ARGENT ESTATES LTD.
EGY KINGS CROSS

CONTRACT NO. 1
GRANARY BUILDING
PROPOSED SLOT WINDOWS
PART SECTIONS 1-1 & 2-2

A1612

Part Detail Plan - Fifth Floor Typical Slot Window @ 1:20

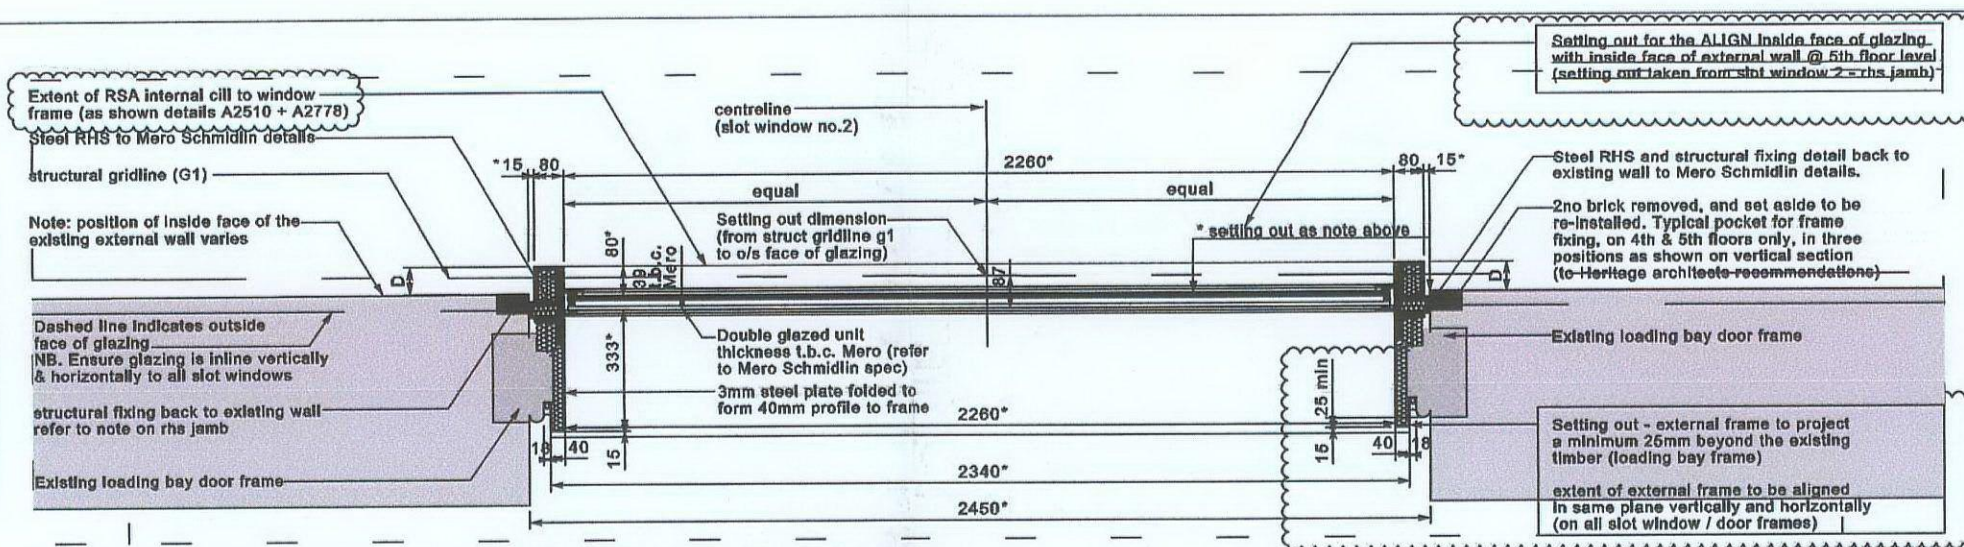
- Revision 7:
- Glazing setting out amended inside face of glazing aligned with inside face of external wall - as shown on detail A2510 - slot window 2 R&S jamb - as shown on the adjacent detail
 - Ensure glazing is inline vertically & horizontally on all slot windows
 - Setting out for the external window frame to extend minimum 20mm beyond the face of the existing timber loading bay frames
